Docket Item #4 A&B

CDD Concept Plan # 2011-0007**Development Special Use Permit #2009-0019**

Application	General Data	
Project Name: Alexandria Sanitation Authority (ASA) Expansion	PC Hearing:	October 4, 2011
	CC Hearing:	October 15, 2011
	If approved, DSUP Expiration:	January 1, 2020
	Plan Acreage:	10.6 acres (4.84 acres within RPA)
Location: 350 and 400 Hooffs Run Drive (Blocks 29 and 30)	Zone:	CDD #11
	Proposed Use:	Utility (wastewater treatment facility) and Office
	Dwelling Units:	n/a
	Gross Floor Area:	60,000 sf - Office
Applicant: City of Alexandria Sanitation Authority (ASA), by Kenneth Wire	Small Area Plan:	Eisenhower East
	Historic District:	n/a
	Green Building:	Comply with Policy – LEED Silver for office building

Development Special Use Permit with Site Plan and CDD Concept Plan for a phased development to include a wastewater treatment facility and other necessary facilities, an athletic field, and an office building.

Double Culvert Bridge

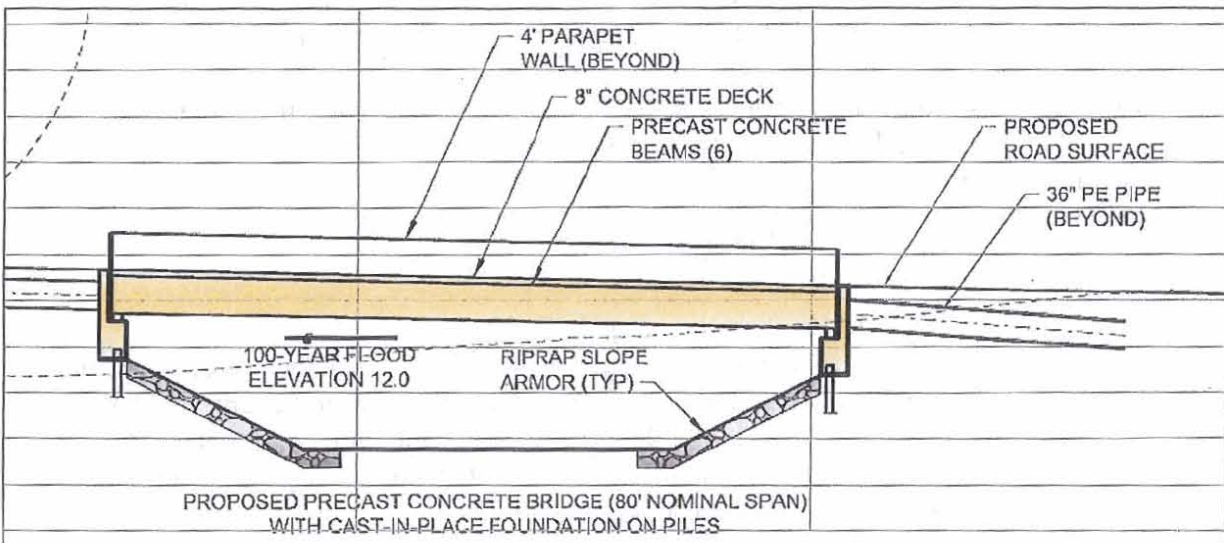
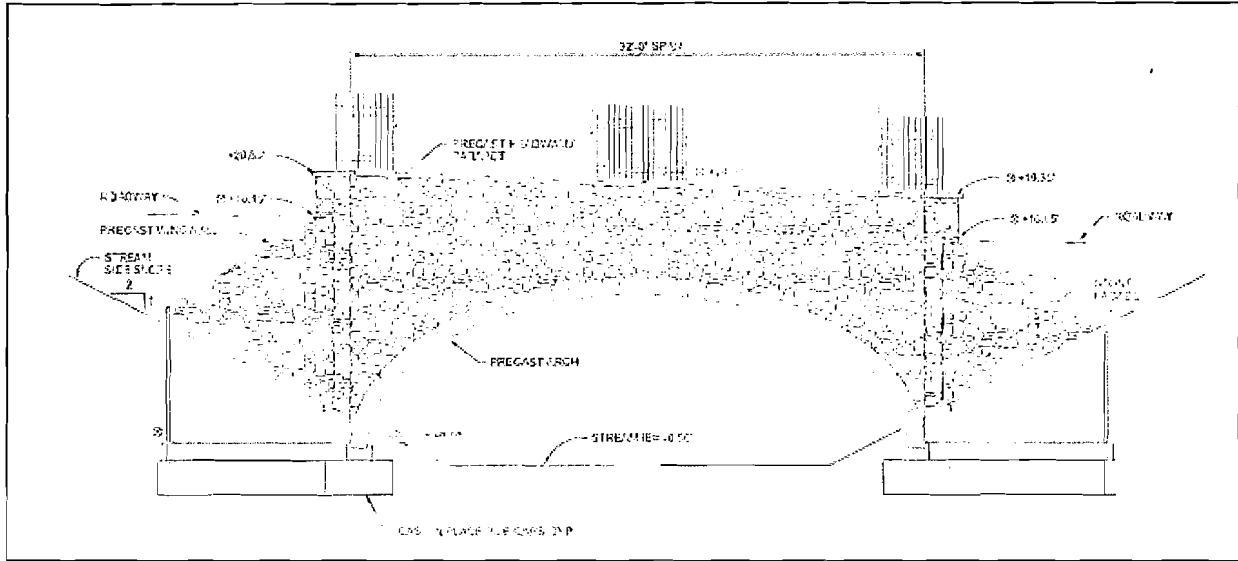
The last component of the first phase is construction of a new bridge over Hooff's Run to link the two ASA sites. The bridge is needed to provide cover for the pipes that will pump wastewater between the two properties and the existing bridge cannot be reconfigured to provide this due to grade of the new Holland Lane extension. Additionally, much of the existing bridge and access road is within the RPA. Although the new bridge will still disturb some portions of the RPA, the area where the road currently is will be restored. The bridge is currently designed

as a double culvert bridge, but may need to be redesigned to a spandrel bridge or single culvert bridge during final site plan depending on possible increases to the size of the pipes and approval from the Army Corps of Engineers (see Attachment #1 for possible bridge designs).

- e. Dedication of the additional right-of-way along Limerick Street. * (P&Z)(PC)
36. The design of the bridge shall be submitted as part of the first final site plan for the tanks and may be revised to the satisfaction of the Directors of P&Z, T&ES, and RP&CA. The design of the bridge shall be consistent with one of the three options provided in Attachment #1. The WQIA and floodplain analysis shall be amended to reflect the proposed bridge design. (P&Z) (T&ES) (RP&CA)
